Manitowoc® Parts & Service Communicator

Subject: Ice Wiper Replacement Required On SN12/SN20 Nugget Ice Machines

OLD STYLE ICE WIPER

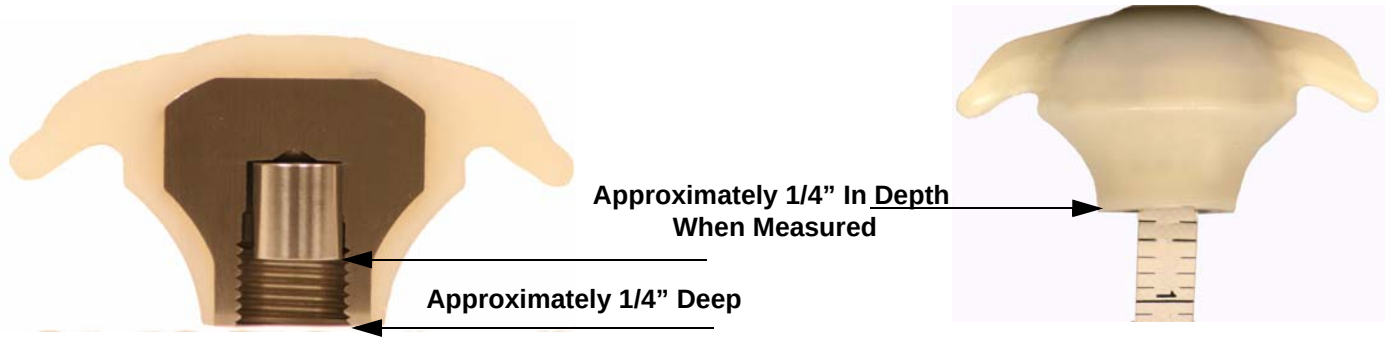
We have made a change to the ice wiper for model SN12/SN20 nugget ice machines. The ice wiper has been redesigned to prevent contact with the upper seal. The symptom of an ice wiper contacting the seal is a squealing noise. All ice wipers for SN12 and SN20 nugget ice machines manufactured before 11/1/06 (before serial number 110578594) must be replaced with the current version wiper (part number 000002062). Refer to the photos below to identify old and new style ice wipers.
